PCN Nu	20201117000.1			P	PCN E	Date: Dec. 11, 2020				
Title:	Title: New Tray for Select Devices									
<b>Customer Contact:</b>		PCN Manager			Dept:		Quality Services			
Propos	ate:	te: Mar. 11, 2021								
Change	е Туре:									
Assembly Site				Design				Wafer Bump Site		
Ass		Data She		eet			Wafer Bump Material			
Assembly Materials			Part number change				Wafer Bump Process			
Mechanical Specification			ı	Test Site				Wafer Fab Site		
Packing/Shipping/Labeling			Test Process		•		Wafer Fab Materials			
	☐ Wafer Fab Process					r Fab Process				
PCN Details

# Description of Change/Change Proposal: 20x20x1.4 LQFP

New tray

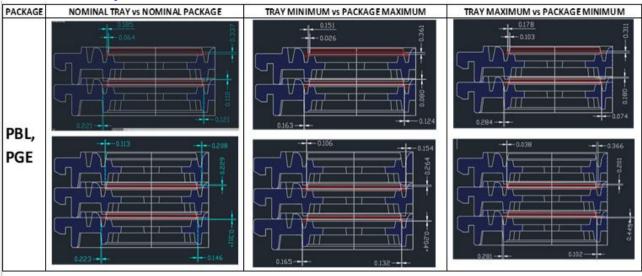
Texas Instruments is pleased to announce the qualification of a new tray for the devices listed below. A comparison summary of the tray differences as follows:

New tray offers improvement on tray warpage, chipping, stuck up caused by current tray
